# **TECHNICAL BULLETINS**

**January 1969 through December 1972**

**Technical Communications Dept. of Technical Engineering**

FIGURE 1. E and E1

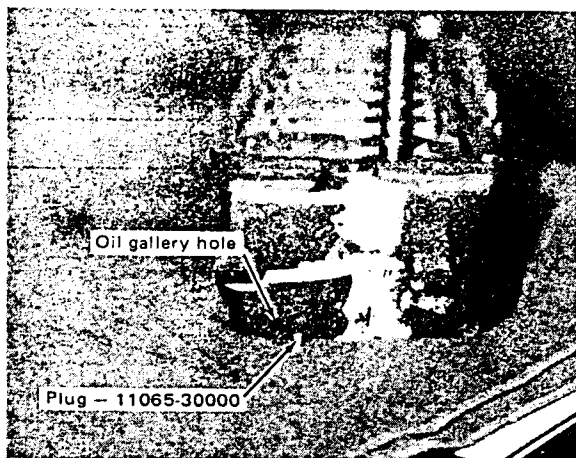
**Service Information.** When ordering a replacement cylinder head, also order the oil gallery plugs. These plugs must be installed in each replacement cylinder head to prevent oil loss and engine damage. To install plugs, first apply Loc-Tite to the chamfered edge of each plug. With the chamfered edge in, hit the plug with a brass drift until the plug seats below the level of the cylinder head. A list of head and plug part numbers, with illustrations showing the location of the plug holes, follows.

A12, L16 engines

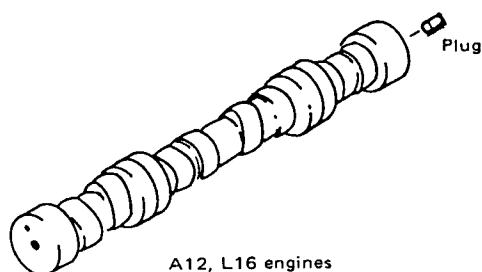
**Service Procedure.** Before installing a replacement camshaft, install the oil passage plug(s). These plugs are necessary to prevent a drop in oil pressure that could result in engine damage. Each camshaft is packaged with the required plug(s). Apply Loc-Tite to the plug, and gently drive the plug into the hole, using a brass drift.

## New First Gear-Servo-Type 4 and 5 Speed Transmissions

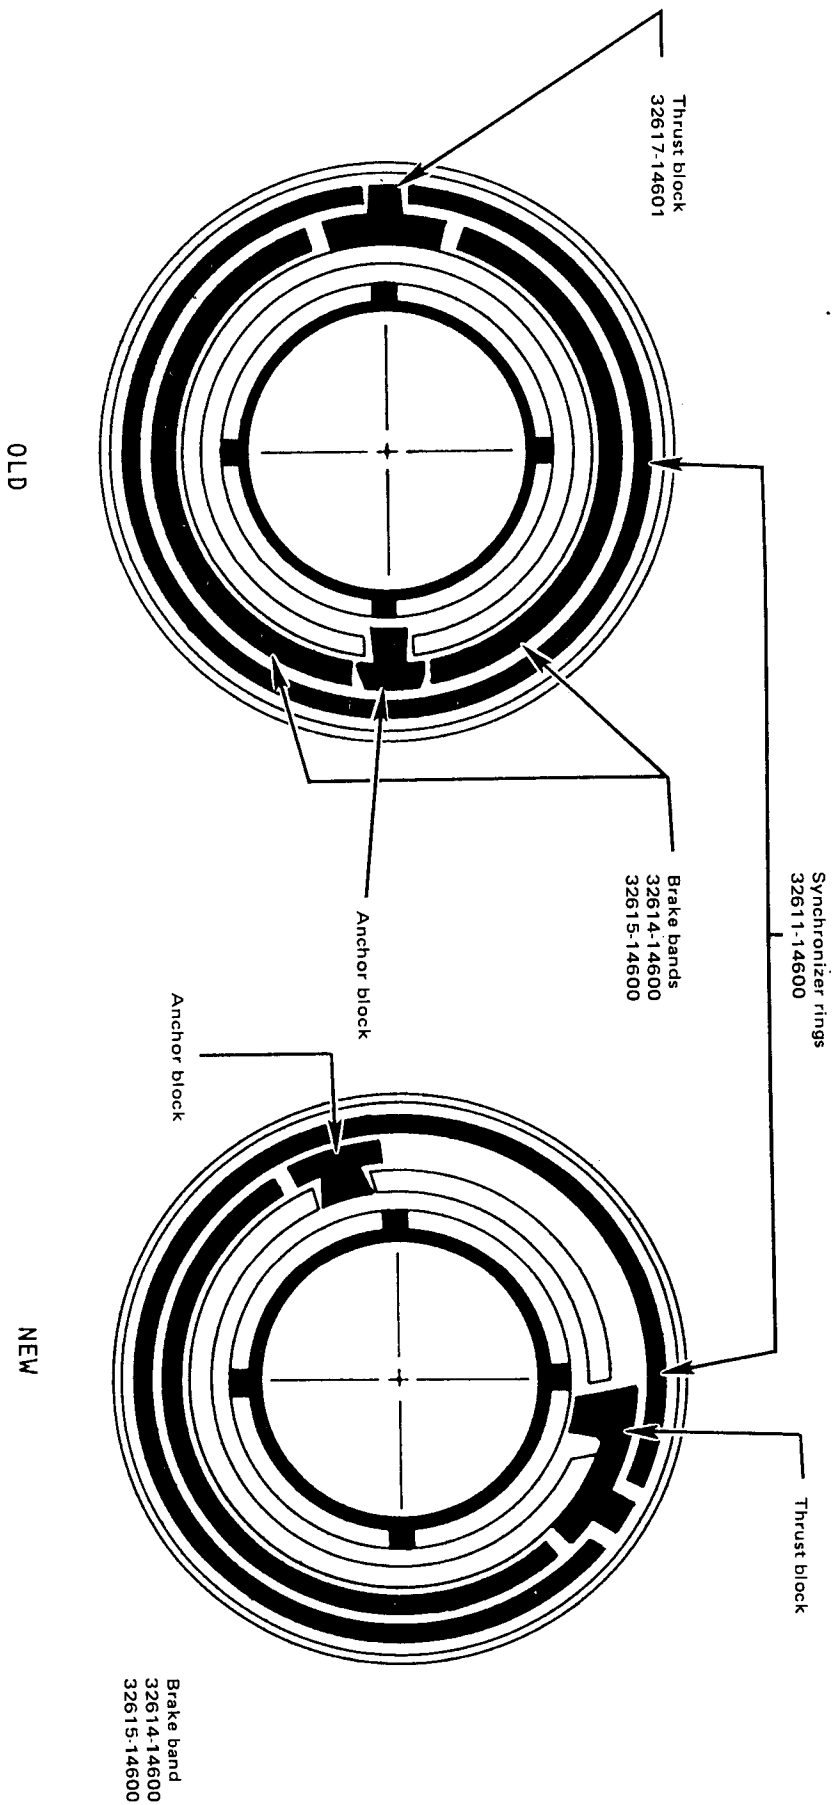
**Production Change.** Modified first gear assemblies are available for use on servo-type four- and five-speed transmissions. The new gear assemblies were installed during production on late model Datsun 1600 and 2000 roadsters. They feature redesigned thrust and anchor blocks, and one of the brake bands has been eliminated (see the attached illustrations). The synchronizer rings and circlips remain the same as those used on the previous assemblies. First gear assembly, part number 32232-14625, is designed for the servo type four speed transmission, part number 32010-14653. First gear assembly, part number 32242-25525, is designed for the servo type five speed transmission, part number 32010-25551. The modified assemblies will interchange with the previous assemblies.

New 1st gear assembly includes new design of thrust block and anchor block Synchronizer Ring 32611-14600 is used with new assembly.  
One brake band is used.  
Circlip (P/N 32616-14600) is used to retain sub assemblies.

## NEW KEY SYSTEM AND KEY NUMBERS

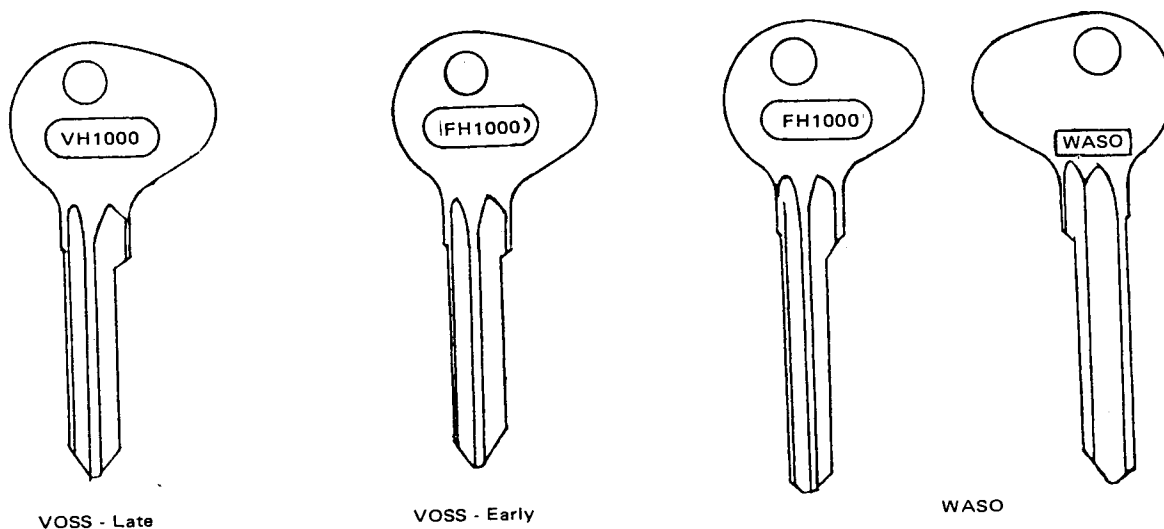
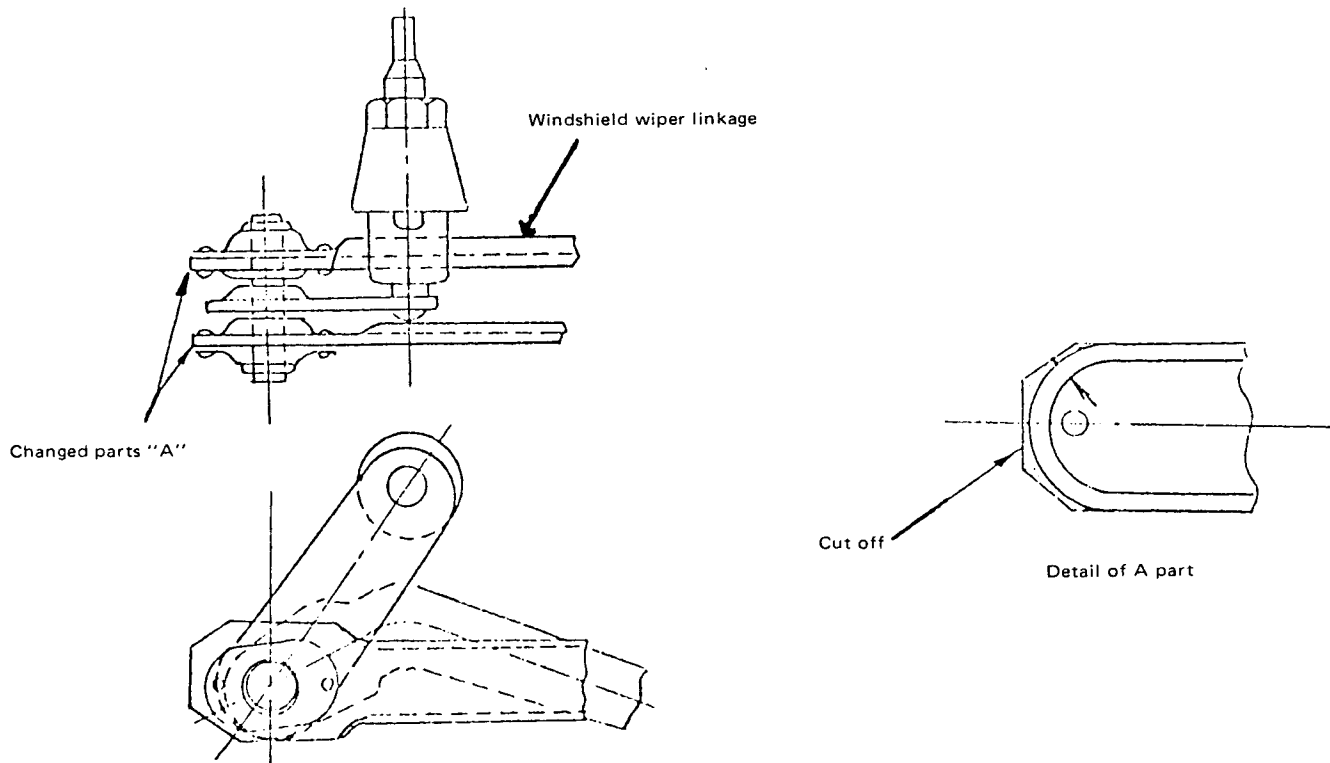
systems. In the table and illustrations, differences between the keys are stated and shown. Note that key profiles did not change, and that WASO keys are longer than VOSS.

Because of its greater length, a WASO key will not fit in a VOSS cylinder. However, a VOSS key could fit into and operate a WASO cylinder, provided only that they have the same key serial number. This can pose a hazard under some circumstances. For example, if a WASO ignition is switched off with a VOSS key, the steering wheel will lock in position before the key is removed from the ignition.

**Interchangeability:** VOSS type is not interchangeable with WASO type. VOSS type key should never be used in WASO type cylinder.

# **WINDSHIELD WIPER LINKAGE MODIFICATION AND CHANGE IN HOLE FOR WIRING HARNESS**

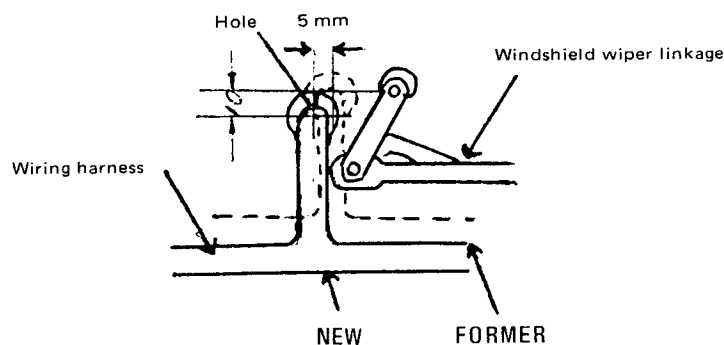
**Production Change.** The windshield wiper linkage has been modified. The windshield wiper linkage rubbed the wiring harness when the wipers were on, causing shorts and other damage to the wiring harness on prior models. These improvements should correct this condition.

*FIGURE 2*

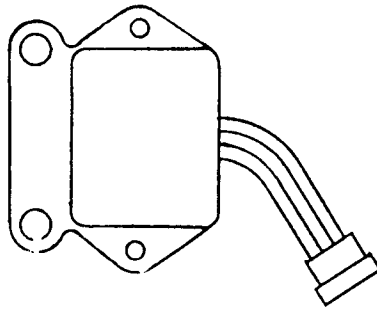
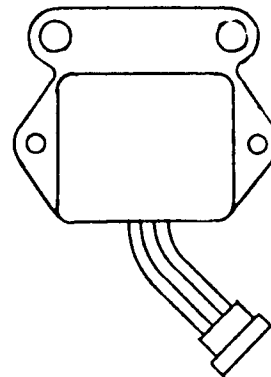
**Production Change.** The headlight relay is being installed horizontally. On earlier serial number vehicles, when replacing relay, install it horizontally as shown in Figure No. 2.
